CITY OF CONWAY, ARKANSAS HISTORIC DISTRICT COMMISSION

HISTORIC DISTRICT COMMISSION

September 22, 2025

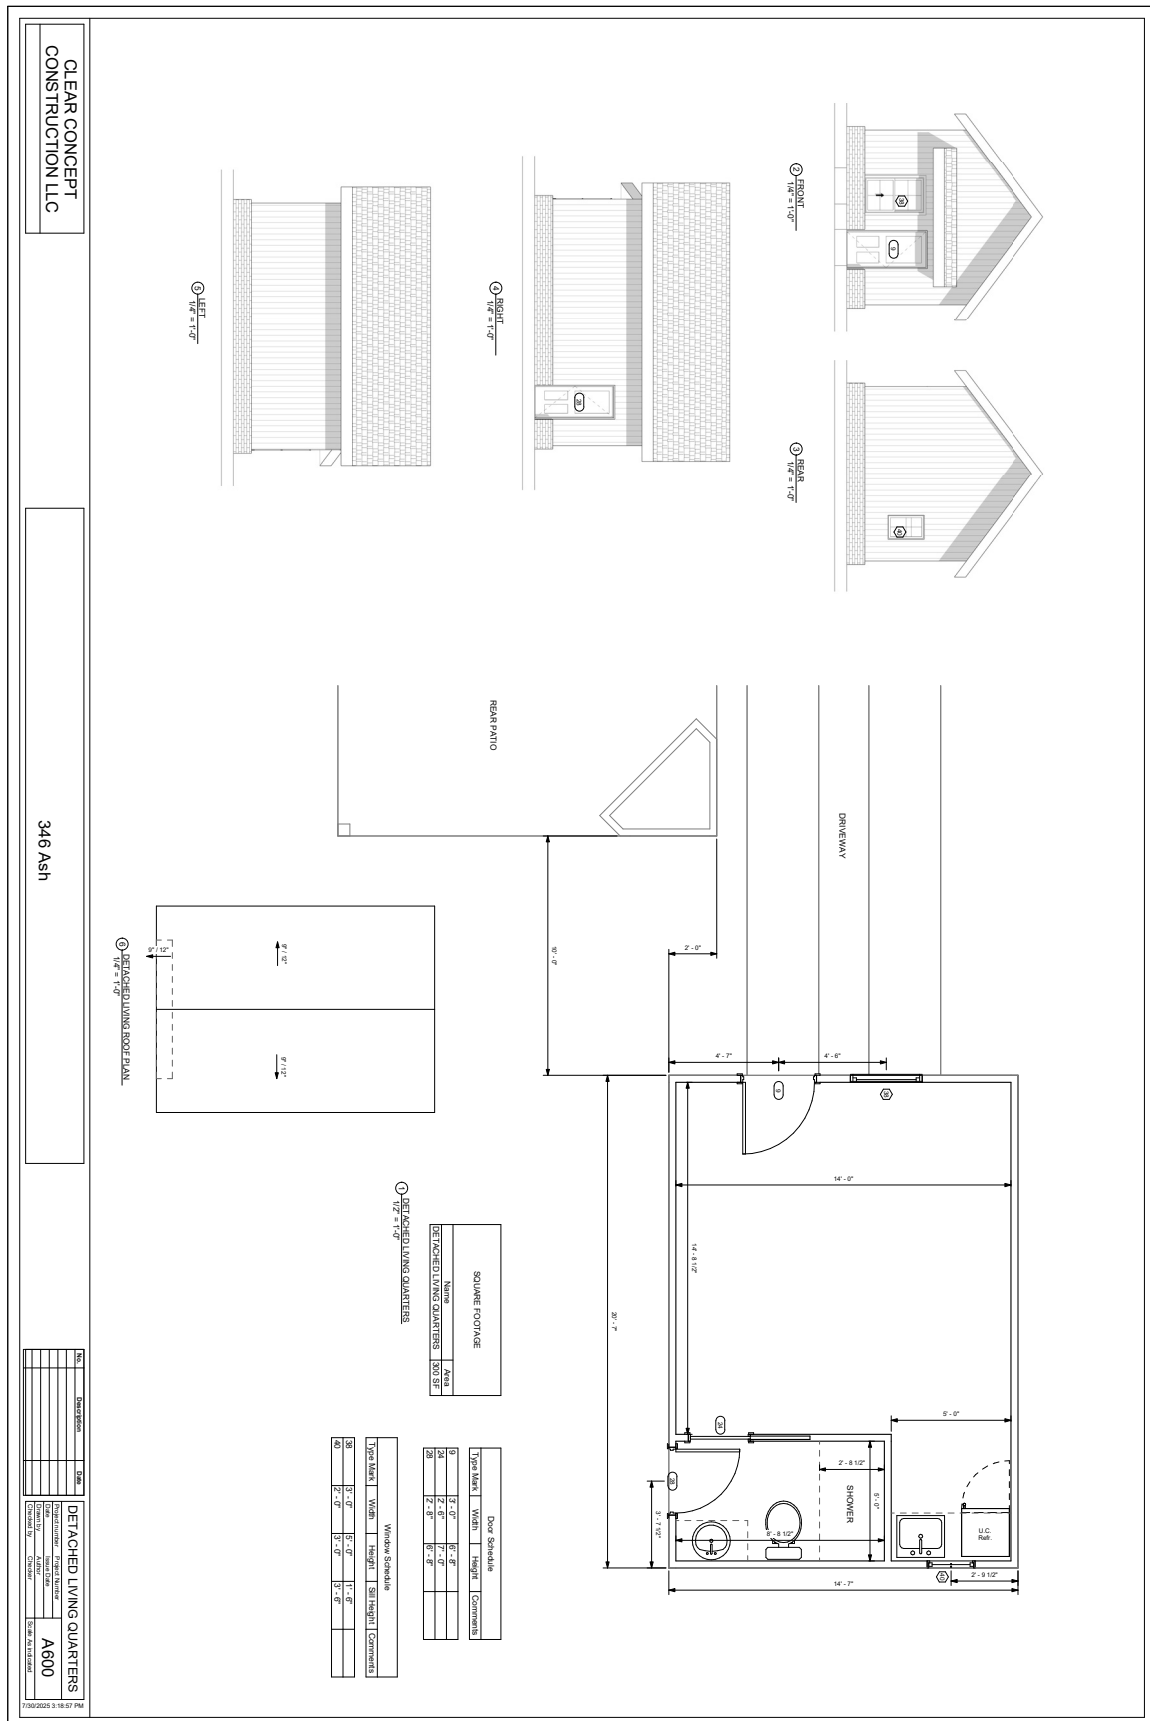
The detached bedroom is 17' from the centerline of the northern alley, more than 21' from the rear setback, and 10' from the single-family residence.

The detached bedroom is placed at the side of the structure along the back portion of the property.

There is a 10' alley along the northern side of the parcel which extends to Center St. It is overgrown and not used as an alley. The applicant will take access from Ash St via a driveway which runs parallel to the alley.

Mechanical system screening. HVAC units should be located where they are not readily visible from the street. If visible, they should be screened with shrubbery or fencing.
No HVAC equipment is shown on the site plan.

1. Applicant must obtain all applicable building permits* if/when a Certificate of Appropriateness is granted.
**Applicant shall provide proof of appropriate licensure of professionals performing work to the Building Permits Department.*
2. There shall be one tree per every 30' of frontage (either retained or planted.) Any trees removed will need to be replanted at a 1:1 ratio. If beneath the power line it shall be an understory tree and if away from the power line it shall be a canopy tree.
3. Lighting shall be downward and inward toward the property.
4. HVAC equipment shall be screened from public view.

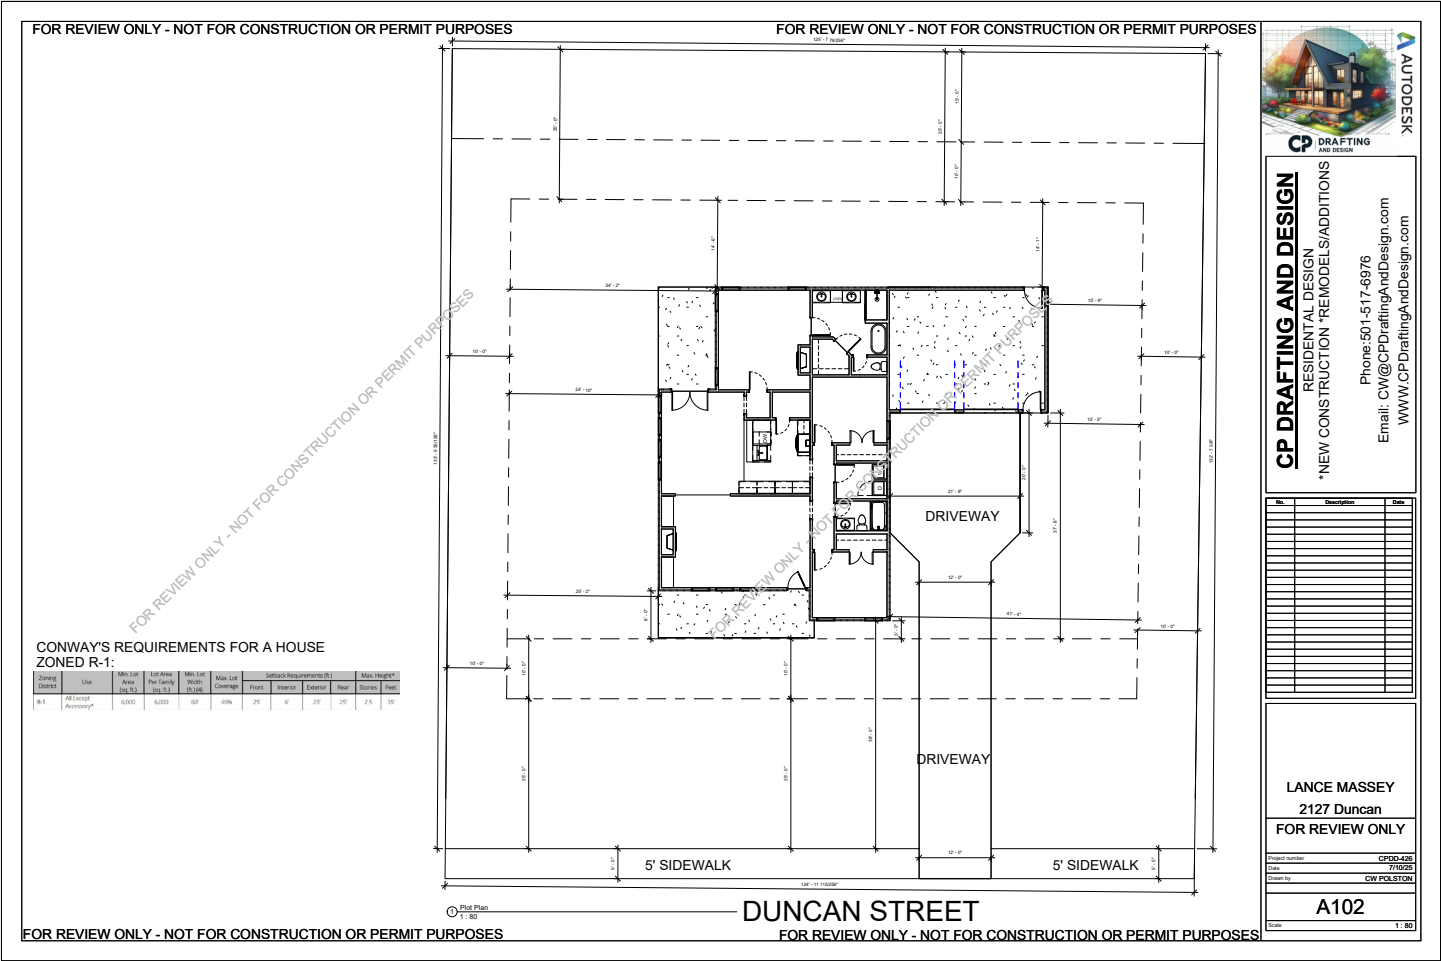
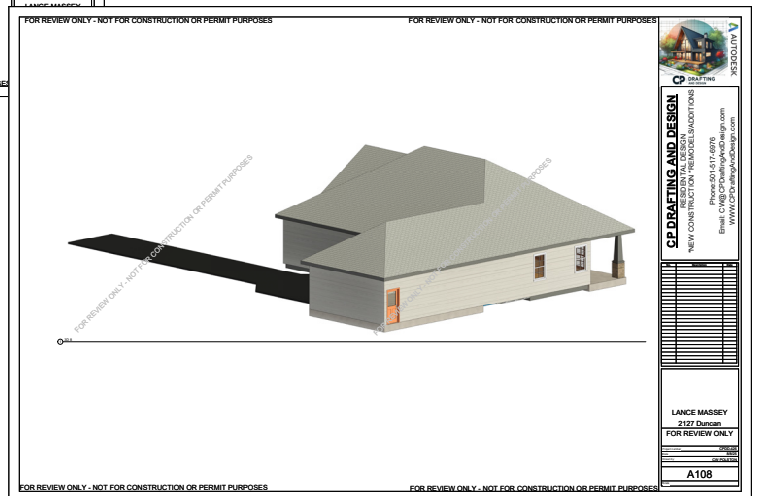
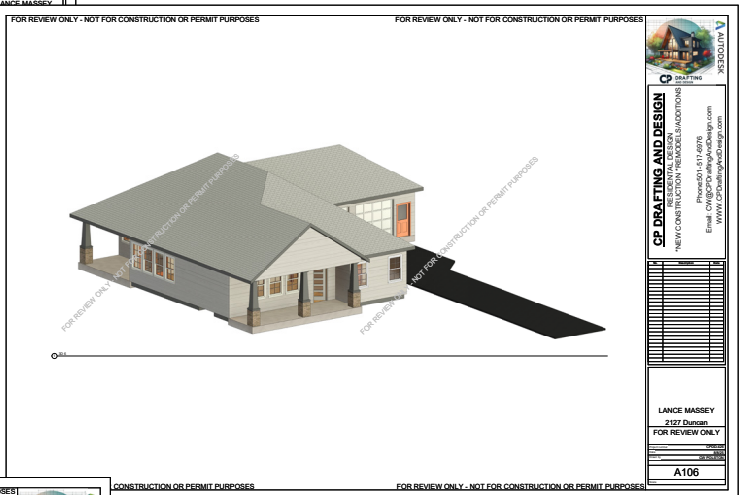
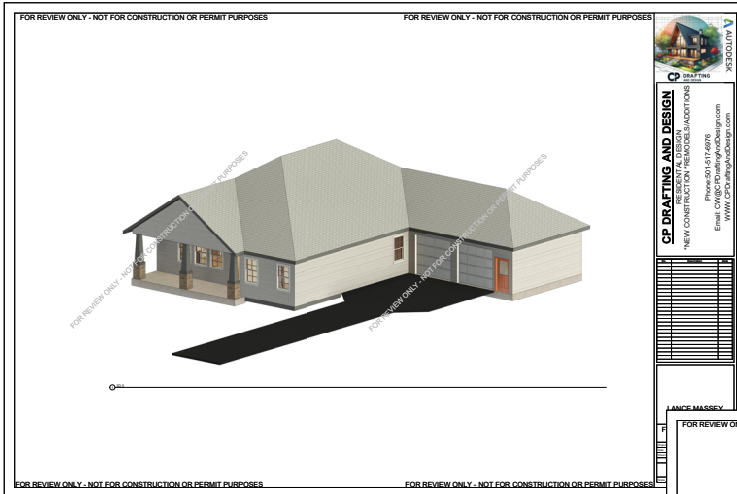
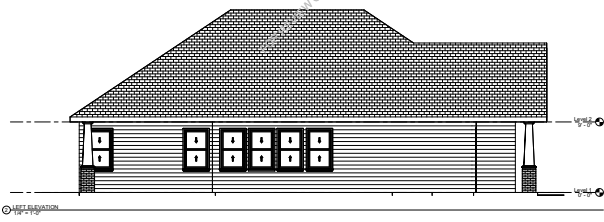
The average front setback for the area is 25', based on five homes on the same block. The applicant is proposing a front setback of 39'. The house will need to have a setback of between 21' and 28' to be in conformance.

The proposal appears to meet these setbacks, however, the site plan dimensions appear inaccurate based upon the platted dimensions and an updated site plan is required.

The driveway material is not specified. The driveway and garage will provide sufficient parking.

Lighting. Any new lighting should be inward, downward, and shrouded so as to stay within the bounds of the property.
Lighting is not shown on proposed plans.

7. Prior to issuance of a Certificate of Appropriateness, the applicant will need to submit to Planning Staff a site plan & elevations showing the following:
- Accurate parcel dimensions.
 - The building in conformance with setbacks.
 - Driveway material and dimensions.
 - A 5' sidewalk with greenspace.
 - One additional window on the western elevation.

1 PRELIMINARY EAST ELEVATION
SCALE: 1/8" = 1'-0"

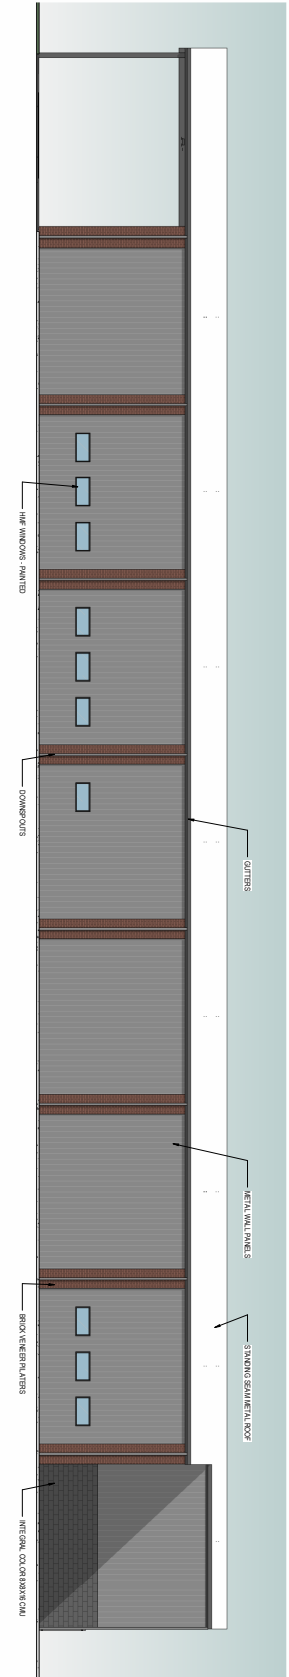
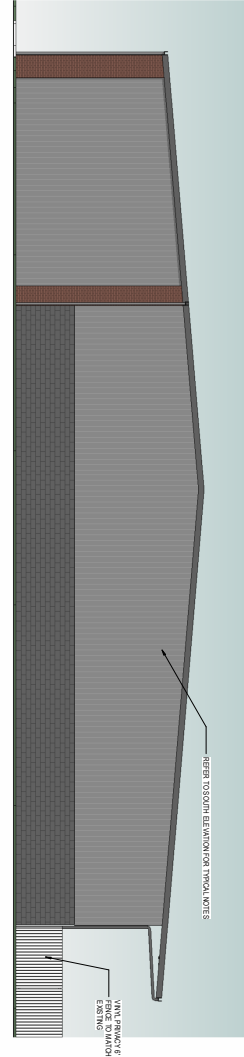
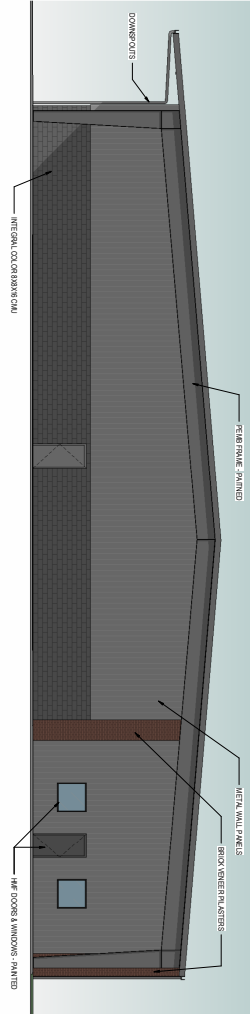
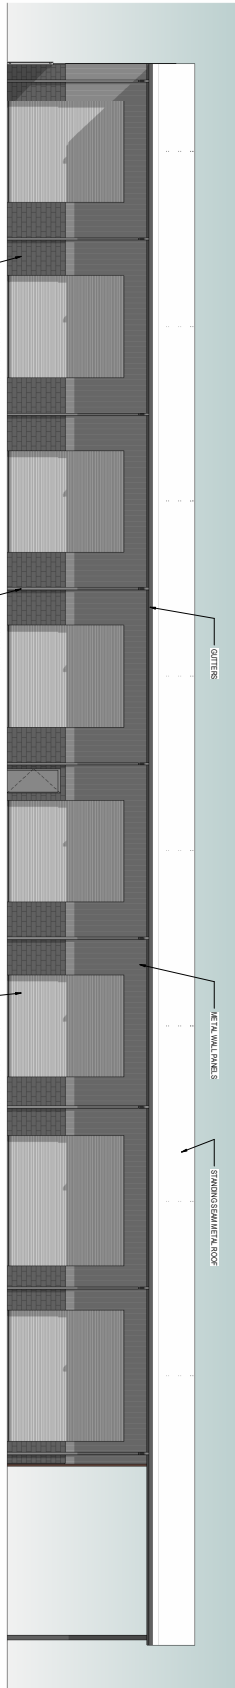
The total lot coverage is unclear as only a portion of the total site is shown on the submitted plans. The applicant will need to submit a site plan showing the total lot coverage for the entire lot.

Applicant has shown 3 trees at the corner of Mill St and Lincoln St. Per this requirement there should be 9-10 trees planted along Mill St and 8-9 trees planted along Lincoln St. Canopy trees could be grouped but with the 3 proposed trees there is a deficit of 14-16 trees. The applicant has not proposed any landscaping to supplement the tree planting requirement.

No building entries are proposed along street frontages.

No overhead cover is proposed.

Lighting is not shown on submitted plans. Lighting will need to conform to Article X standards and will be reviewed during the SDR process.

4. Prior to issuance of Certificate of Appropriateness, the applicant shall submit for review by planning staff, a site plan and elevations showing:
 - Structures built to appropriate setbacks *unless Commission allows a 0' setback.*

- Additional landscaping in the form of trees or shrubs planted along street frontages.
 - Material percentage breakdown.
 - Lot coverage tabulation for the entire site.
